Wollongong Local Planning Panel Assessment Report | 1 June 2021

WLPP No.	Item 1
DA No.	DA-2020/805
Proposal	Residential - dual occupancy and tree removal
Property	56-64 Asquith Street, AUSTINMER NSW 2515 Lot A DP 369644
Applicant	Mrs Lisa Joan Hughes
Responsible Team	Development Assessment and Certification – City Wide Planning Team (MB)

ADDENDUM REPORT

Figure 1
Eastern elevation demonstrating topography and 9m LEP height maximum line

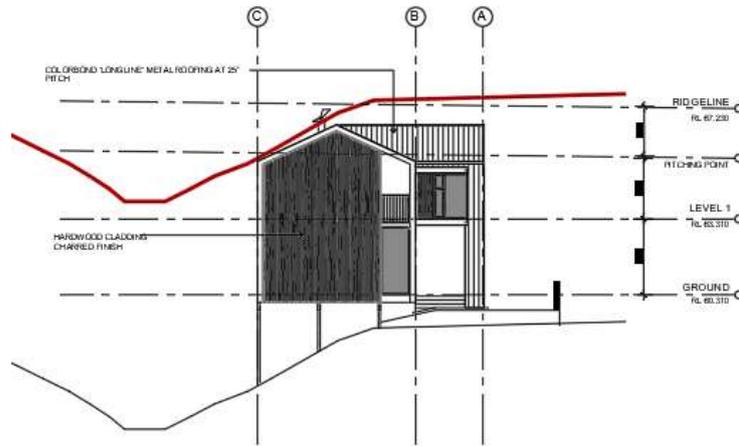
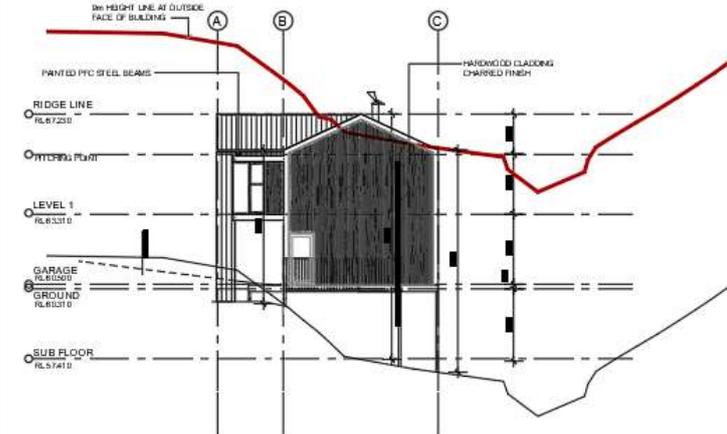
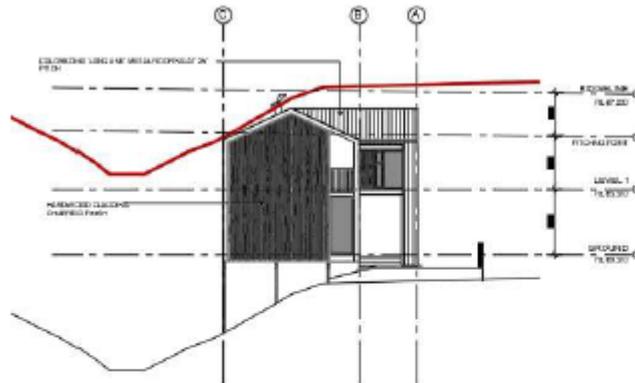
<p>(b) that there are sufficient environmental planning grounds to justify contravening the development standard.</p>	<p>There are sufficient planning grounds to justify contravening the building height development standard as it relates to the proposed variation as it meets the following criteria:</p> <ul style="list-style-type: none"> • There will be no unacceptable adverse environmental impacts as a result of the proposed development and the outcome will not result in a negative impact in relation to visual impact, loss of views, loss of privacy or overshadowing of adjoining properties considering both existing and future allowable development. • The proposal is considered to be satisfactory having regard for other provisions of the WLEP2009 and the relevant chapters of WDCP2009 • The proposed bulk and scale of this development is considered appropriate for this location and will not detrimentally affect the visual appearance of the area with the location of the variation being sought in this instance being towards the rear. • The area of the dwelling that requires variation does not increase the visual impact of the dwelling when viewed from the street,

WLEP 2009 clause 4.6 proposed development departure assessment	
Development departure	Clause 4.3 of WLEP 2009, the maximum building height permissible for the site is 9 metres. The proposed height of 9.85 metres exceeds the maximum by 0.85metre (9.44%).
Is the planning control in question a development standard	Yes
